TECHNICAL SERVICE BULLETIN

Classification: FA24-002	Reference: ITB24-005	Date: April 23, 2024
-----------------------------	-------------------------	-------------------------

POPPING NOISE FROM FRONT SUSPENSION WHEN TURNING

APPLIED VEHICLES: 2022-2024 QX60 (L51)

Figure 1

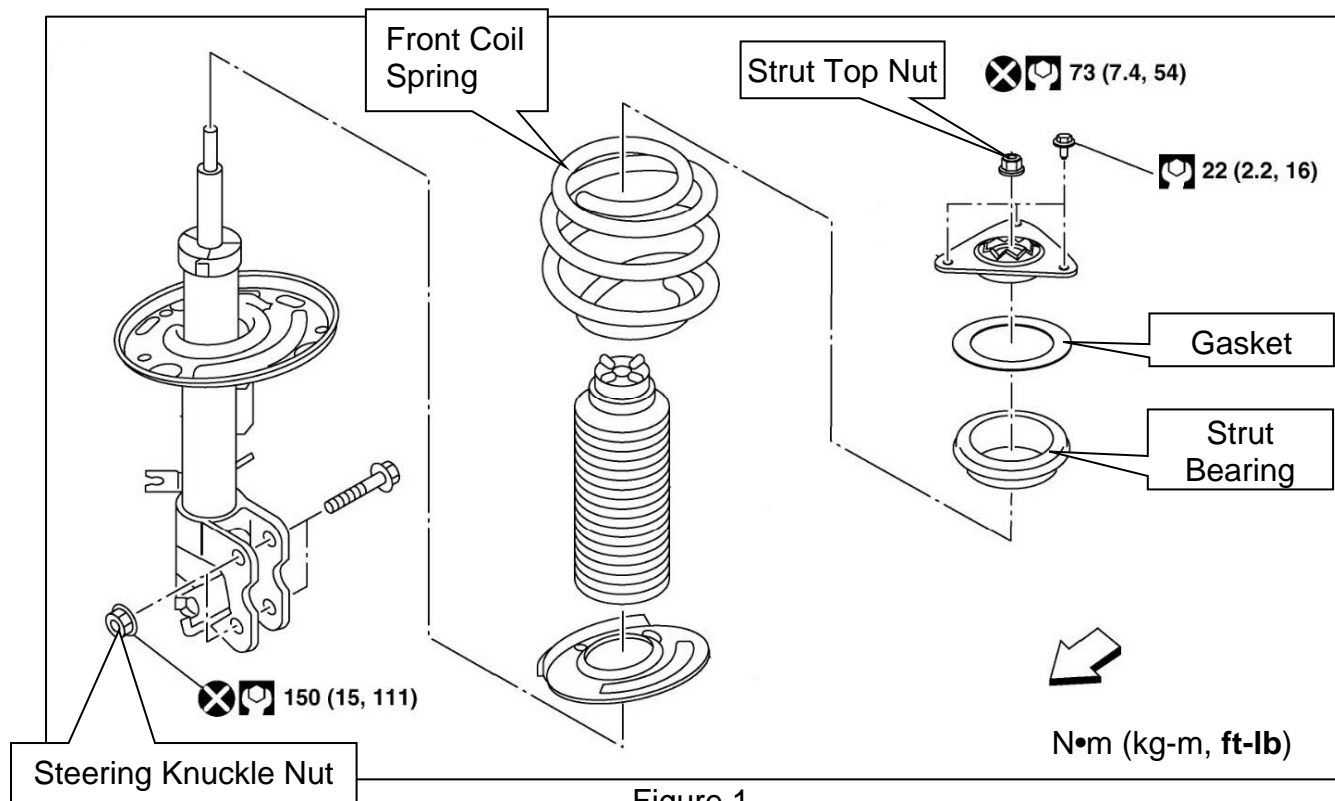
- For an effective repair, all parts called out in Figure 1 must be replaced. These parts are also listed in the **PARTS INFORMATION** on page 7.

HINT: The Stabilizer Connecting Rod Nut, not shown in Figure 1, will also need to be replaced.

- The incident noise may return if all listed parts are not replaced.
- The **Coil Spring Installation Guidelines** section in this bulletin **MUST** be followed in order for a correct repair to be performed.

If this bulletin applies, replace the front coil spring, strut mount bearing, and all other associated parts for the side(s) that is popping, with those listed under **PARTS INFORMATION** on page 7.
